MVM PAKS II. ZRT.

**ERECTION OF NEW POWER PLANT UNITS AT THE
PAKS SITE**

ENVIRONMENTAL IMPACT STUDY

CLARIFICATION OF FACTS

Figure 3-1: The impact of water retention actions characterised by alternatives of the Cunovo / Gabčíkovo barrage system in the low water level periods recurrent in every 20 000 years on the security of the water extraction possibilities for the Paks Nuclear Power Plant (Danube, 1526.5 river km)

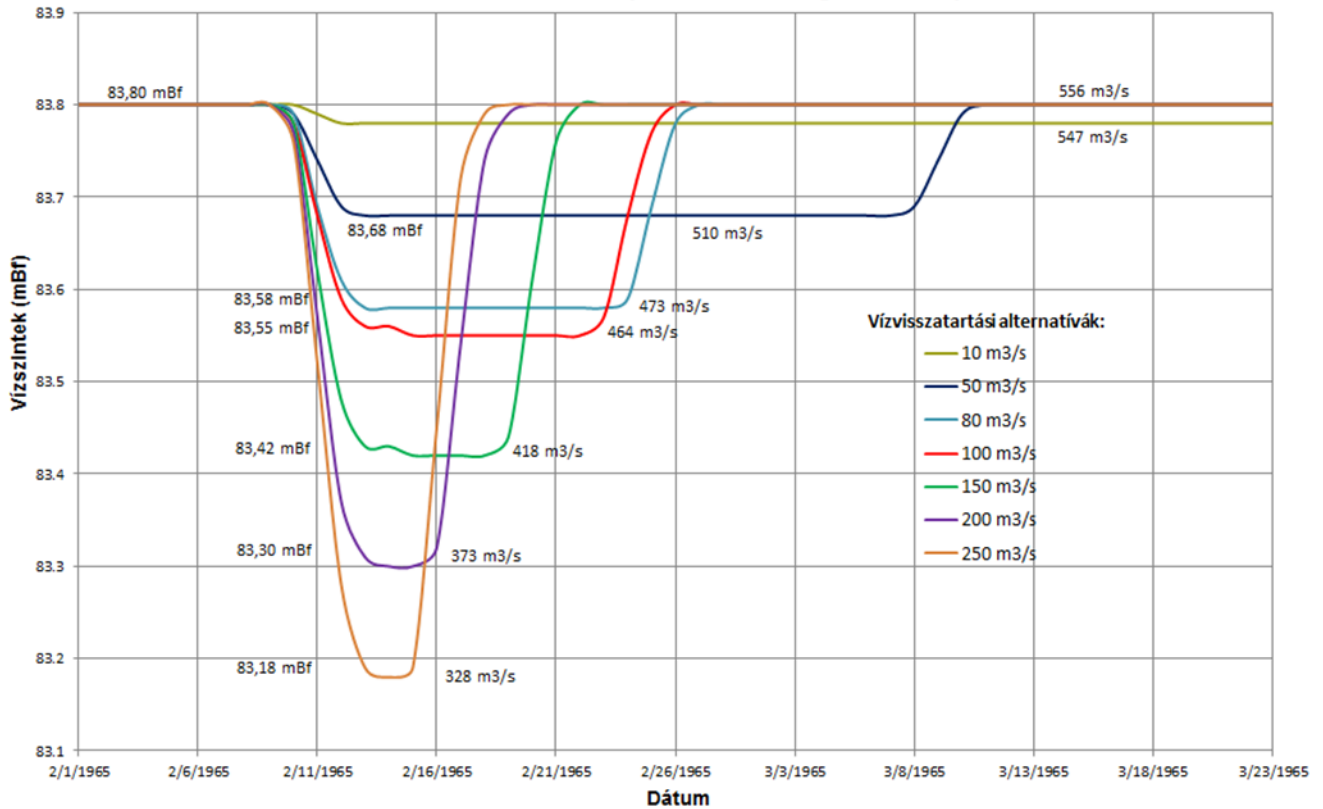
3 In Table 6.6.5-1 of Chapter 6.6.5.1 the hydrological foundations of the lowest water levels LKV=83.80 metres above Baltic sea level provided for the Danube Paks profile for the year 2032, and the 83.60 metres above Baltic sea level water level calculated from this parameter for the mouth profile of the hot water channel are doubtful. We disagree with the methodology applied and in our view the calculated values cannot be regarded representative. The Danube water levels expected during the proposed lifetime of the cold water channel, water levels required for operability and their relations compared to each other are not presented.

Out of the water levels mentioned above the water level of 83.80 metres above Baltic sea level is a predicted lowest water level (mouth water level) expected in the year of 2032 and derived from the Paks city watermark post (1531.3 river km) to the nuclear power plant profile (1527 river km). The other figure, 83.60 metres above Baltic sea level provides water level of the cold water channel measured at the water extraction plant at the time of low water stages and calculated with an average surface decline of 20 cm (embayment water level).

The design water level from which the pumps are able to provide cooling water to the condensers in the water extraction work is at 82.00 metres above Baltic sea level.

In the period after 2032 the required amount of water is gradually decreasing due to the continuously shut down units, and after 2037 cooling water is needed only for the proposed new units. As a consequence of the joint impact of reduced needs for Danube water and the extended cold water channel the low water stage encountered as a result of the sinking Danube river bed bottom and the low water stages incurred at the end of the operating period will not limit the delivery capacity of the pumps.

Based on the following figure of the EIS (11.9.2-5.) it can be concluded that the extreme low water level situations recurrent in every 20 000 years occur in the case of the current river bed at approximately ~83.80 metres above Baltic sea level.

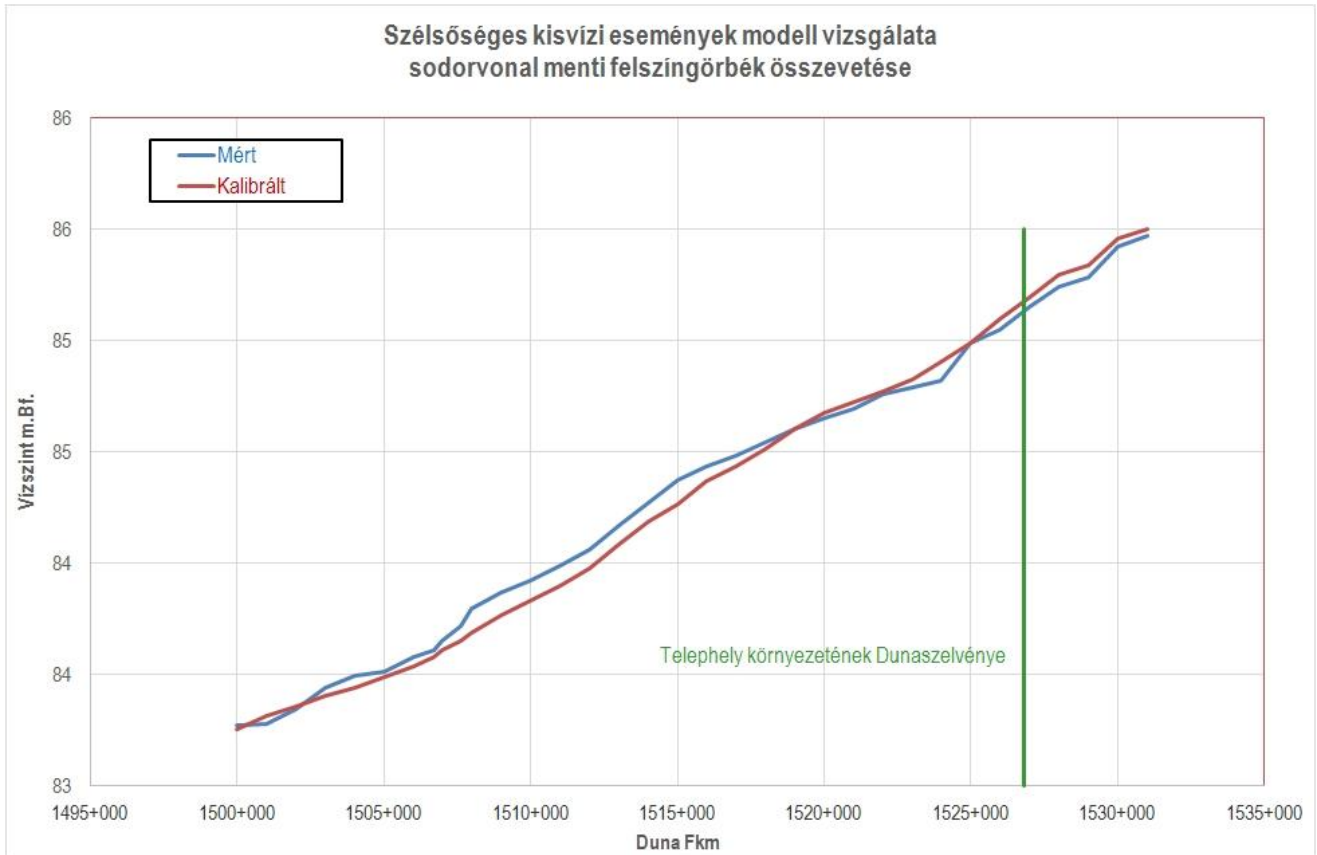
- 4 The material on the Danube modelling (EIS_II.pdf) claims that the low water flow calibration of the computerised hydraulic model was prepared for DB “0” water level. (Table 11.6.1-3 – Page 35). It is not indicated which period of time the DB “0” water level concerns, and that it was not a measured, but calculated, theoretical water level. We think it was necessary to present the connection between the river bed state constituting the basis for the DB “0” water level taken into account for the purposes of the model calculations and the river bed model prepared for the EIS. Should the assessment basis of the river bed models be different, the morphology changes occurring during the period in between the survey dates may distort the value of DB “0”, thus resulting in a faulty low water stage calibration. Correctness of the calibrations to be carried out during modelling must be checked by validation. The documentation does not contain any information on the verification process and its outcome for either high or low water stages.**

Calibration of the 2D flow model (proportioning of the river bed roughness factor distribution) was calculated for the high water flow (culminating at Paks in June 2013 at 8790 m³/s) and water levels, using Danube river bed particulars from the year of 2012. For the areas of different uses initial roughness factors were taken based on the experiences gained from Danube modelling exercises.

Due to a very good concurrence of the calibrated and measured water surfaces, furthermore because the good correlation between surface curve calculated for the low water stage quasi permanent water volume rate of flow measured on the Danube on 6 October 2011 (1242 m³/s at Paks) and the actually measured water surface the calculations were seen as validation exercises. Study model calculations were carried out using the river bed morphology figures from the year 2012 (source: MVM Paks Nuclear Power Plant), with a volume rate of flow of 579 m³/s on the Danube. Results are summarised below as a supplement to Chapter 11.6.1.2.3 (Low water flow calibration) of the EIS:

Calibration of the 2D flow model developed for the Danube section between 1500 to 1530 river km at low water flows is illustrated on the following figure as a supplement to the EIS (see: **Annex No 1: 1_Melleklet_Sebessegmezok**).

The calculation of the calibrated surface curve included in the EIS (Chapter **11.6.1.2.3: Calibration for low water stages**) (Figure 11.6.1-15 and Table 11.6.1-3) was made for the Danube river bed particulars of the year 2004 and the water yield associated with the surface curve measured by the Danube Commission in 2004 (taking effect in 2006) (1180 m³/s). This and the EIS are to be complemented with the calculation results presented above.

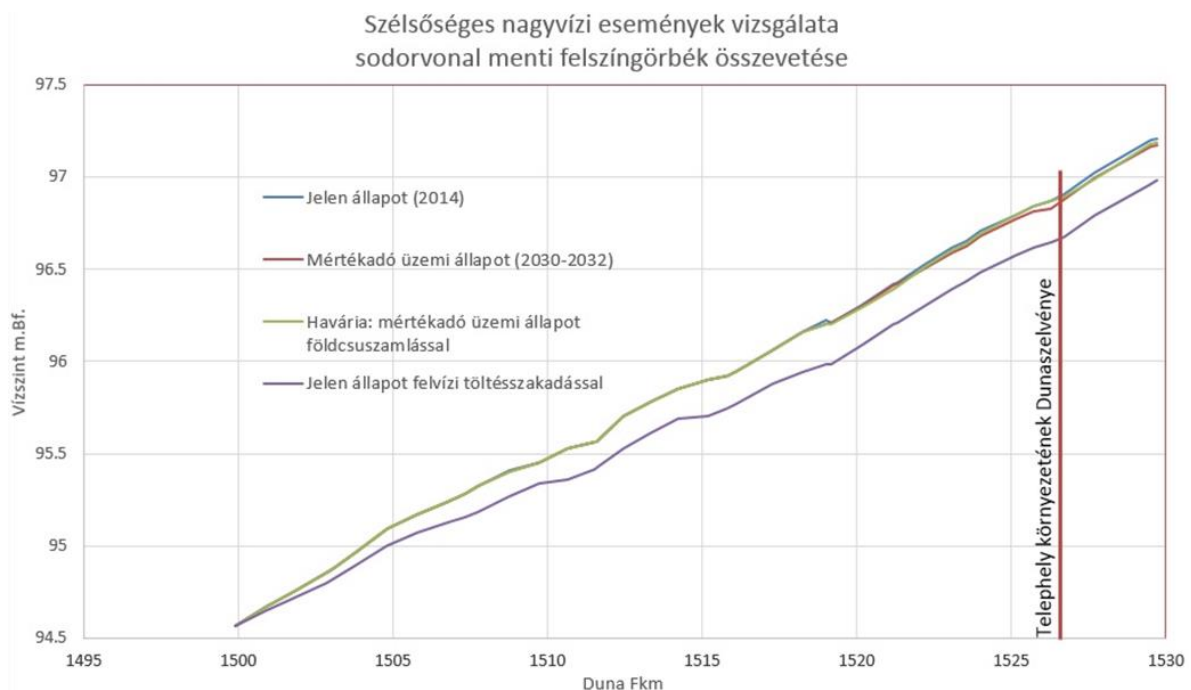
- 10 We cannot agree with the statement that the flood level determined for a frequency recurrent in every 20 000 years cannot be formed because the current level of the crest on the left bank dike is lower than this (Chapter 11.7.1.2, Page 79). Flood levels exceeding the current elevation of the dike crests can be successfully controlled by temporary control works as demonstrated in the past two decades on the river Tisza.

The water surface formed in the case of the water flow on the Danube recurrent in every 20 000 years (14 799 m³/s) was determined in the EIS using a 2D hydrodynamic model between the 1500 – 1530 river km profiles.

Namely, the current crest levels of the flood control works were elevated along the entire Danube section modelled (Danube 1500 – 1530 river km profiles) so that the water level reducing effect of the water spilling over the dike crest at the current crest levels of the embankments (in the Power Plant profile the right bank crest level is currently at 96.30 metres above Baltic sea level, on the left bank 95.80 metres above Baltic sea level) were not taken into account.

For the sake of safety, the value of the water flow recurrent in every 20 000 years was not reduced due to the fact that the crest of the flood may be reduced substantially if expected inundations occur on the higher reaches of the Danube.

Based on the model calculation the water level on the Danube culminates at 96.90 metres above Baltic sea level in the event of an extreme flood event (a flood flow rate recurrent in every 20 000 years), under the most unfavourable conditions (for the sake of safety it was assumed that the current flood control works on the Danube are developed in the future and the passing flood can be contained within the embankments with the help of protection measures against floods) in the surrounding of the existing and proposed site.

It is visible that it will not threaten the ground level at 97.00 metres above Baltic sea level of either the existing or the proposed site of the development by static inundation, but provided the wave motion becomes more intensive for whatever reason, it may generate an emergency situation and may affect vulnerable objects on the surface or in the public utility ducts. **Therefore the vulnerable objects situated close to the surface are recommended to be provided by active protection (parapet wall, etc.), and such protection installed for the proposed development.**

Figure 11-1: Calibration of the River2D model for 1 242 m³/s Danube flow rate

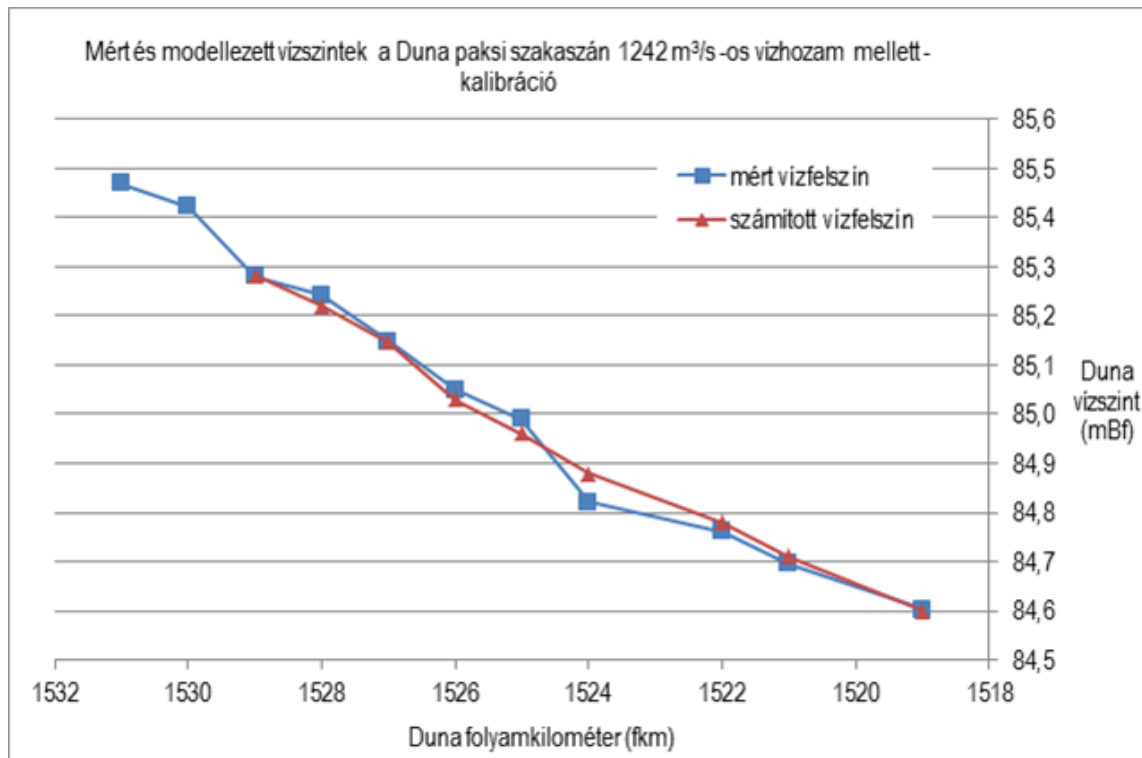
- 11 Only two figures were found about the examination of the flow conditions in Chapter 11.8.1.2. The impact of the erection of Paks II on the flow space and river morphology changes in the Danube, which contain the depth integrated flow fields associated with a flow of 2300 m³/s on the Danube and a water extraction/flow rate of 100 m³/s. The EIS does not contain any such results from series of tests which would have applied higher level of water use and lower levels of Danube flow rates, although the design state for the purpose of navigation would be represented by extreme low water flows and the highest levels of water use throughout the operation period.

The 2D flow calculations have been completed taking into account the nearly permanent surface curve and water volume rate of flow (1242 m³/s) measured on 6 October 2011:
